**Marty Stuart's Congress of Country Music – Ellis
Theater Renovations**

MECHANICAL/PLUMBING BID PACKAGE

ADDENDUM NO. 2

TO: All Bidders on the Above Referenced Product
FROM: Dryden Architecture + Design
DATE: October 14, 2021
SUBJECT: **ADDENDUM NO. 2**

2 SHU-1 ELEVATION
1/4" = 1'-0"

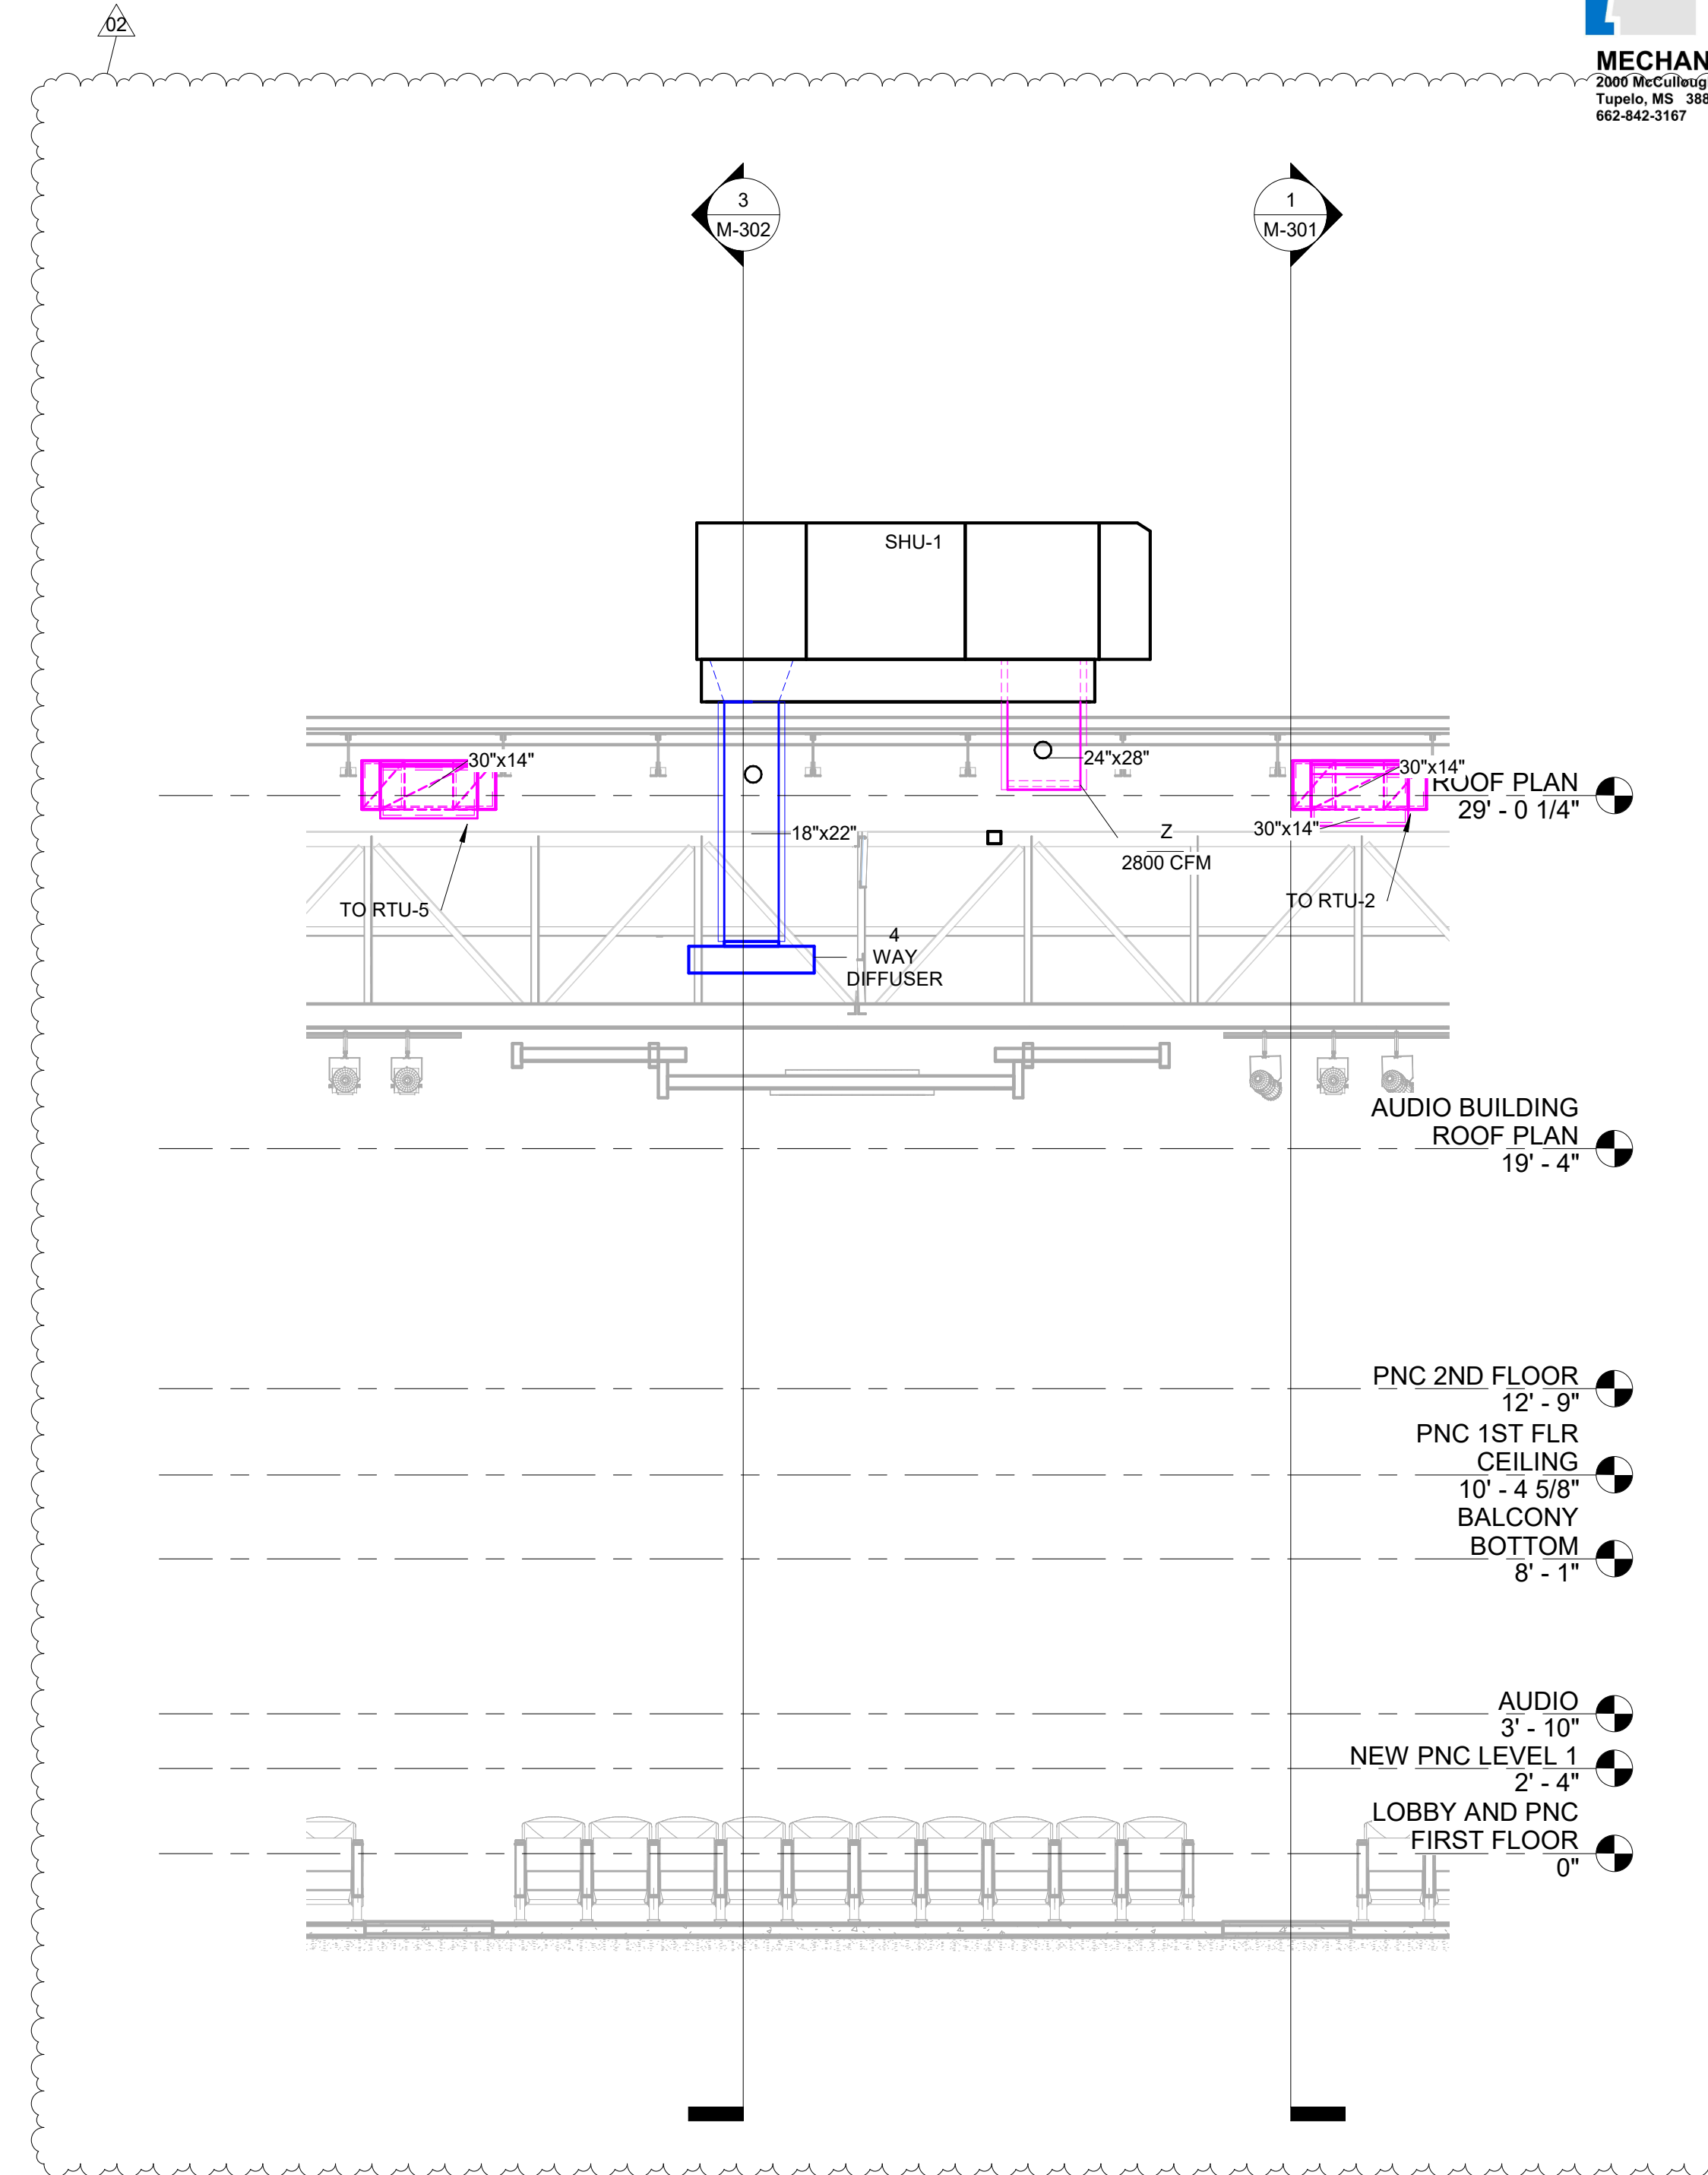
ALTERNATE REMOVED
